# Wisconsin Department of Transportation

**Proposal #43: 4348-05-71, WISC 2022175**  
**T Rockland, CTH JJ**  
**Manitowoc River Bridge**  
**CTH JJ**  
**Manitowoc County**

This is Addendum No. 01, which provides for the following:

**ADDENDUM NO. 01**

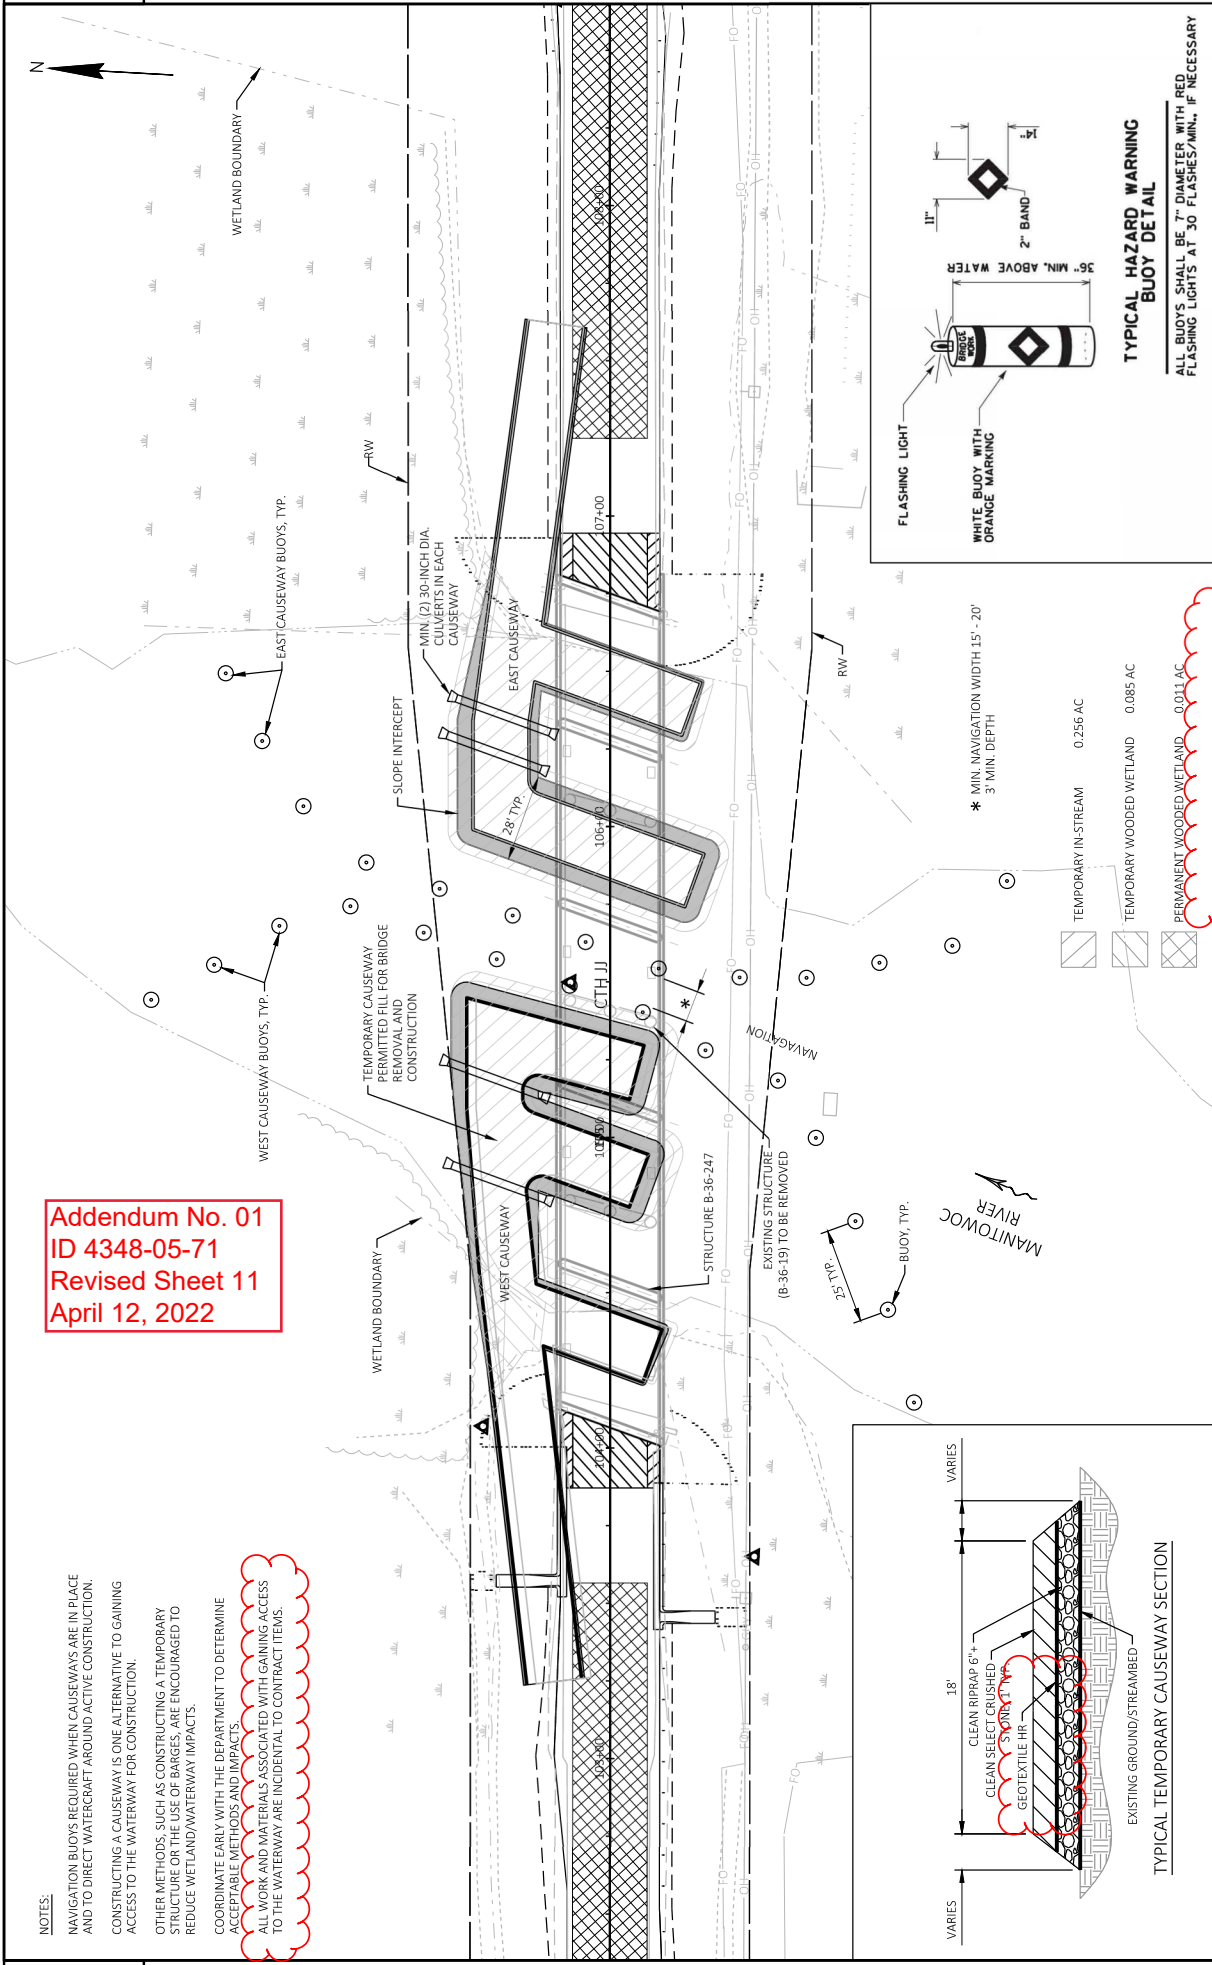
Revised Plan Sheets	
Plan Sheet	Plan Sheet Title (brief description of changes to sheet)
11	Temporary Causeway Concept – Title and Misc Updates

NOTES:  
NAVIGATION BUOYS REQUIRED WHEN CAUSEWAYS ARE IN PLACE AND TO DIRECT WATERCRAFT AROUND ACTIVE CONSTRUCTION.  
CONSTRUCTING A CAUSEWAY IS ONE ALTERNATIVE TO GAINING ACCESS TO THE WATERWAY FOR CONSTRUCTION.  
OTHER METHODS, SUCH AS CONSTRUCTING A TEMPORARY STRUCTURE OR THE USE OF BARGES, ARE ENCOURAGED TO REDUCE WETLAND/WATERWAY IMPACTS.  
COORDINATE EARLY WITH THE DEPARTMENT TO DETERMINE ACCEPTABLE METHODS AND IMPACTS.  
ALL WORK AND MATERIALS ASSOCIATED WITH GAINING ACCESS TO THE WATERWAY ARE INCIDENTAL TO CONTRACT ITEMS.
